EXHIBIT C
DRAFT RESOLUTION

**CVR HSGE LLC (CARMEL VALLEY RANCH)
(PLN180281)**

[PLN180281, CVR HSGE LLC, One Old Ranch Road, Carmel Valley, Carmel Valley Master Plan, Carmel Valley Ranch Specific Plan APN: (416-522-020-000)]

C4.0

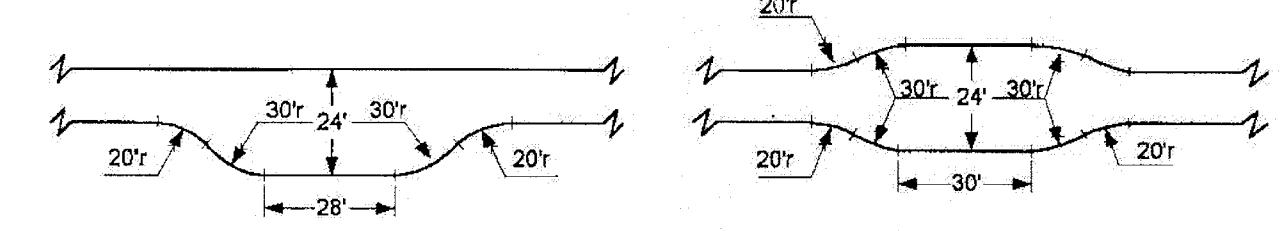
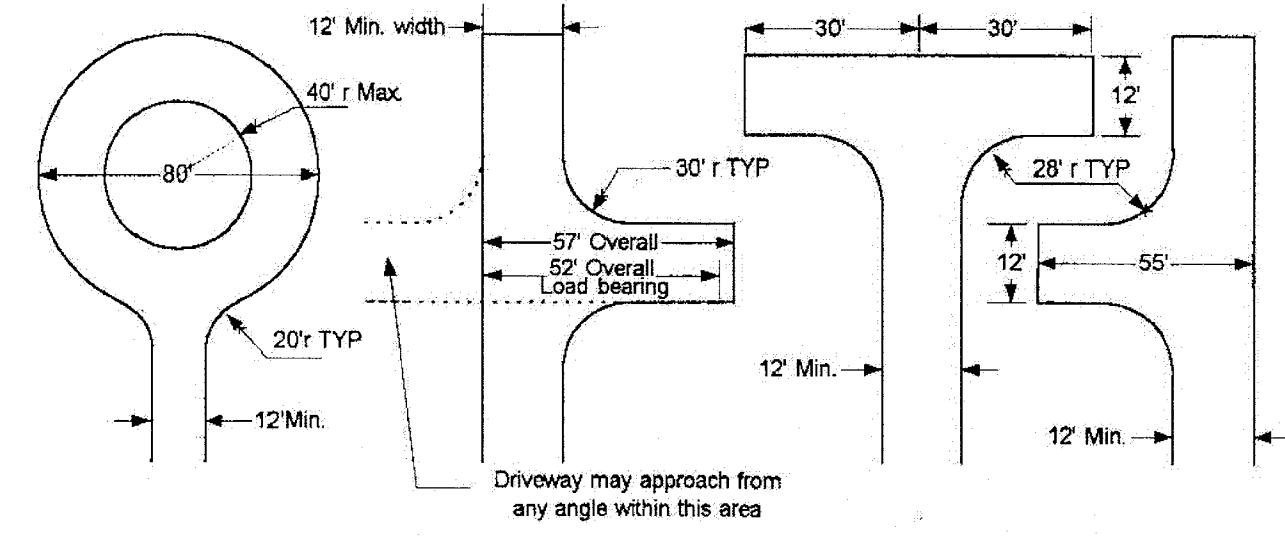
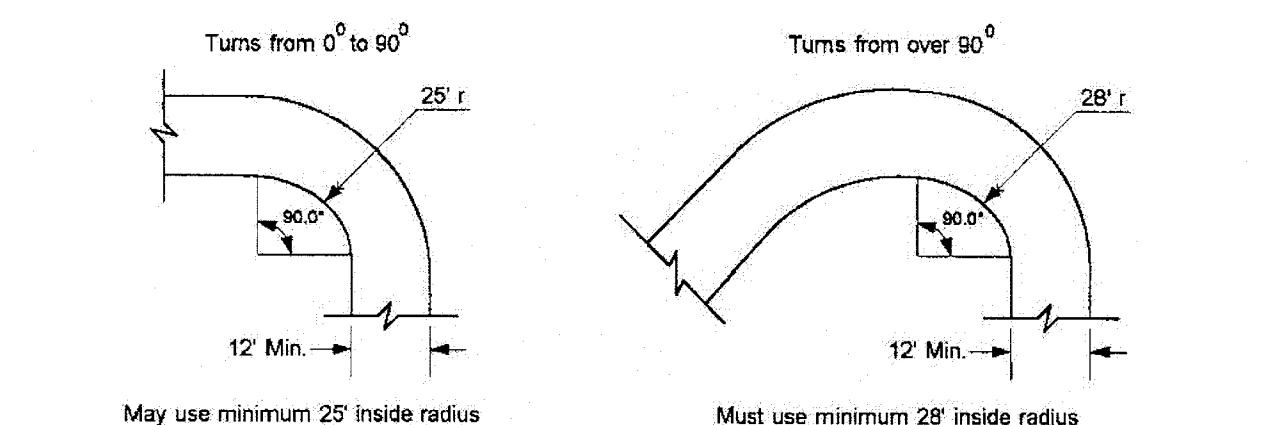
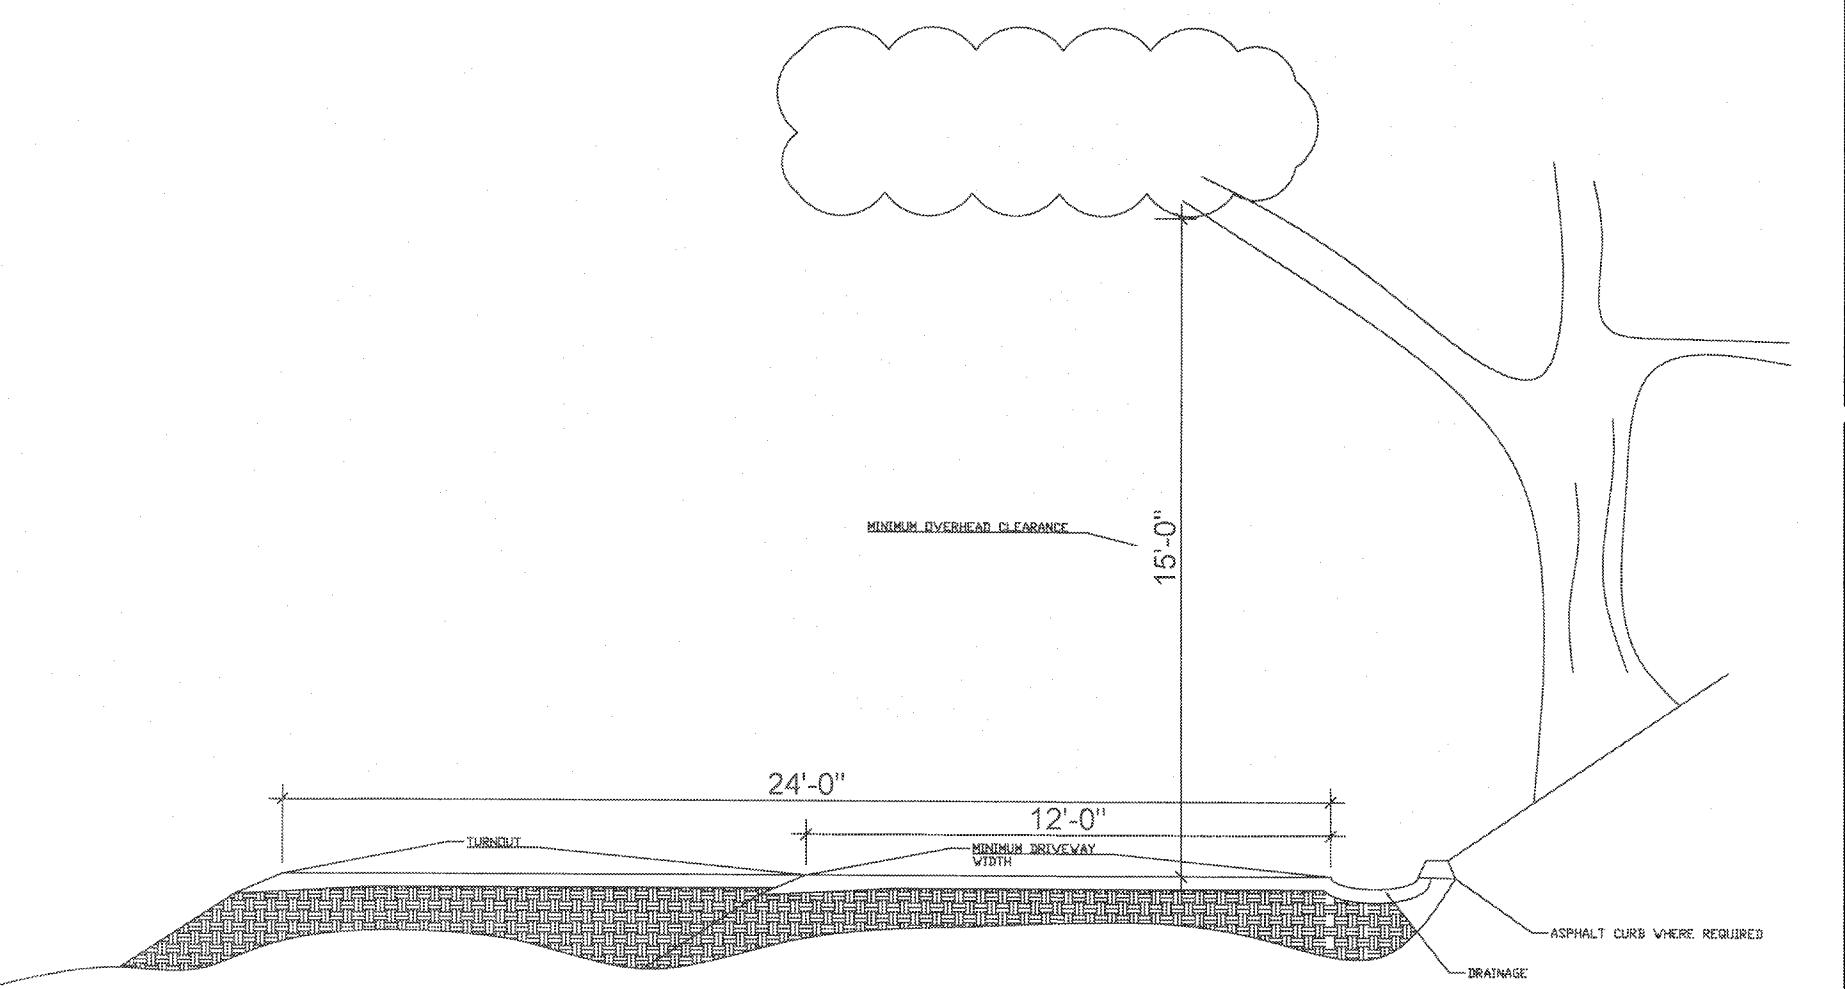
PLAN REVIEW 5/30/2018

COMMENT RESPONSES

MC Fire :

- PLANS HAVE BEEN REVIEWED TO COMPLY WITH CRC SECTION R327.
- A) ROOF MATERIAL IS CLASS A (CORRUGATED STEEL). ROOF GUTTERS SHALL BE STEEL WITH STEEL $\frac{1}{2}$ SQUARE SCREEN.
- B) NO ROOF VENTING IS REQUIRED, OPEN RAFTER SHADE STRUCTURE.
- C) ROOF COVERING DOES NOT HAVE ENCLOSED ATTIC SPACE, SPRINKLERS ARE NOT PROPOSED.
- D) NO EXTERIOR WALLS ARE PROPOSED.
- E) IF EXTERIOR WALLS ARE REQUIRED FOR SHADE OF ANIMALS THEY WILL BE FIRE RESISTANT MATERIAL.
- F) ALL CONSTRUCTION IS 2X LUMBER OR LARGER SOLID WOOD.
- G) NO EXTERIOR GLAZING IS PROPOSED.
- H) DOORS SHALL BE SOLID CORE WOOD IF USED. AT THIS TIME NO DOORS ARE PROPOSED.
- I) STRUCTURE IS NOT INTENDED FOR CONTINUOUS HUMAN OCCUPATION. THE BUILDING SERVES AS A SHADE STRUCTURE FOR ANIMALS.
